Subject: Portland Bureau of Development Services Code Guide, April 27, 2017

Fire Safety Plan Review Checksheet Response

Permit #: 16-212152-REV-01-CO

HYDROCARBON UNIT

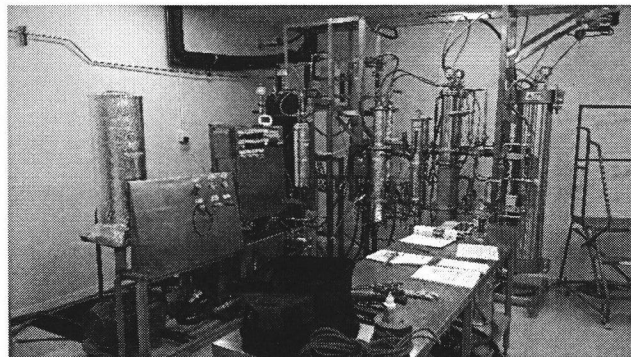
By Design Engineering has confirmed the hydrocarbon and carbon dioxide extraction systems are installed per the design intent guidelines and documents. Please see the Vitalis and Hydrocarbon Oil Extraction engineering reviews.
